# Access Compliance Report
Public Rights-of-Way
(Curb Ramps)

Intersection ID: 32120	Main Street: ALLENWOOD_RD	Cross Street: DUNDALK_RD	Location:	N
ADA ID: ACDE27361481	Ramp Type: PerpDiag	Initial Pass/Fail: Fail	Overall Compliance: No	Severity Score: 8.75

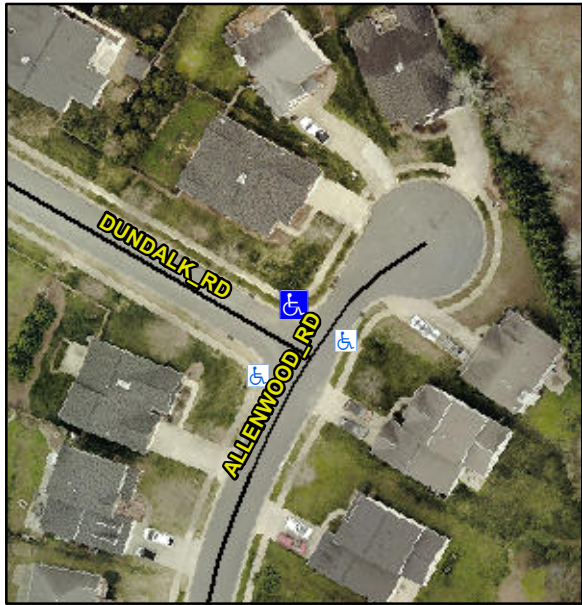
Not Found, R304.5.1

Compliance	Description	Data	Compliance	Description	Data
N/A	Ramp Length (in)	54.0	Yes	Ramp Slope (%)	7.8
No	Ramp Width (in)	37.5	Yes	Ramp XSlope (%)	1.4
N/A	Flare Type LT	N/A	N/A	Flare Type RT	N/A
N/A	Flare Slope LT (%)	N/A	N/A	Flare Slope RT (%)	N/A
N/A	Flare Traversable LT?	N/A	N/A	Flare Traversable RT?	N/A
N/A	Landing Length (in)	N/A	N/A	DWS Provided?	N/A
N/A	Landing Width (in)	N/A	N/A	DWS Contrast?	N/A
N/A	Landing Slope (%)	N/A	N/A	DWS Length (in)	N/A
N/A	Landing X Slope (%)	N/A	N/A	DWS Full Width?	N/A
N/A	Landing Curb? (Y/N)	N/A	N/A	DWS Offset (in)	N/A
N/A	Shared Landing?	N/A			
N/A	Gutter Ponding?	N/A	N/A	Gutter Slope (%)	N/A
N/A	Gutter Lip Ht (in)	N/A	N/A	Gutter X Slope (%)	N/A
N/A	Painted X Walk1?	No	N/A	Painted X Walk2?	No
	X Walk 1 Direction	To SW		X Walk 2 Direction	To SE
N/A	X Walk 1 Width (in)	N/A	N/A	X Walk 2 Width (in)	N/A
	X Walk 1 Slope (%)	0.6		X Walk 2 Slope (%)	0.6
	X Walk 1 X Slope (%)	0.9		X Walk 2 X Slope (%)	1.5

Remove & Replace Curb Ramp With Two New Directional Ramps or Equivalent.
